### REMARKS

This application has been reviewed in light of the Office Action dated February 19, 2008. Claims 1-18 are presented for examination, of which Claims 1, 9, and 12 are in independent form. Claims 3, 4, 8, 9, 12, and 13 have been amended to define Applicant's invention more clearly. Favorable reconsideration is requested.

Fig. 7  
~~State of the Art~~  
Prior Art

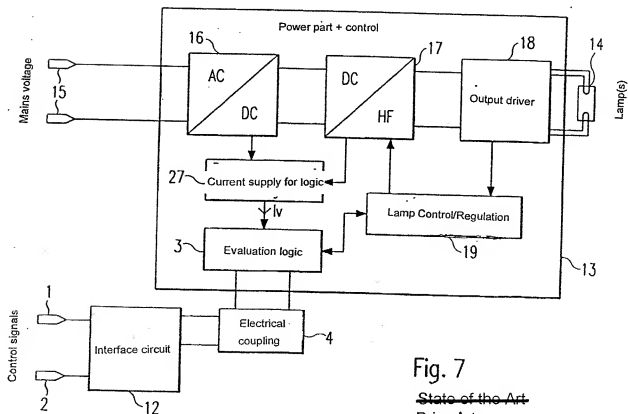
Submitted herewith is an Annotated Drawing Sheet and a Replacement Sheet of corrected drawings, which includes changes to Figs. 6 and 7. In amended Figs. 6 and 7, 'State of the Art' has been changed to 'PRIOR ART'. Applicant submits that the amendments to the drawings add no new matter to the original disclosure. Approval of the amended drawings is respectfully requested.
